Subject: Grand Gulf Nuclear Station
Docket No. 50-416
License No. NPF-29
Changes to Emergency Plan Implementing Procedures – June 5, 2001

GNRO-2001/00047

10-S-01-29
Revision: 16
Date: 5/25/01

OPERATIONS SUPPORT CENTER (OSC) OPERATIONS

Maintenance Shop Upper Level

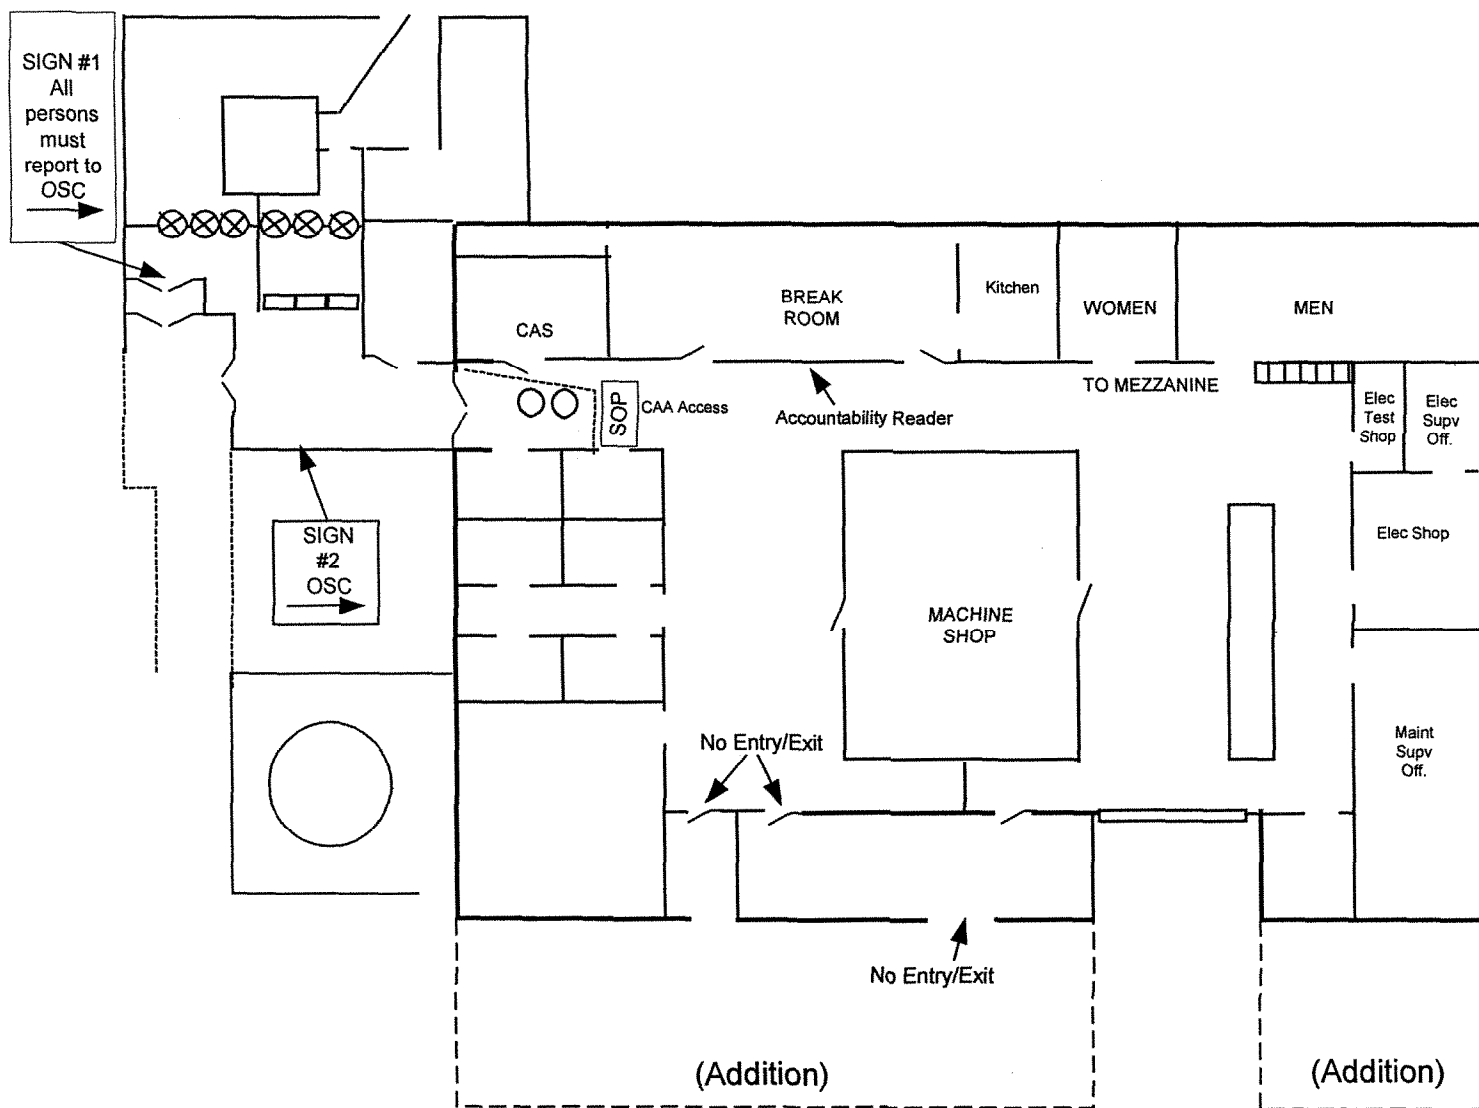
- Adds requirement for On-Shift Electrical maintenance personnel to call in additional Maintenance personnel if the required number of Maintenance personnel are not on site to support ERO staffing.
- Corrects OSC entrance instructions and layout for additions made to the Maintenance Shop.
- Grammatical changes.
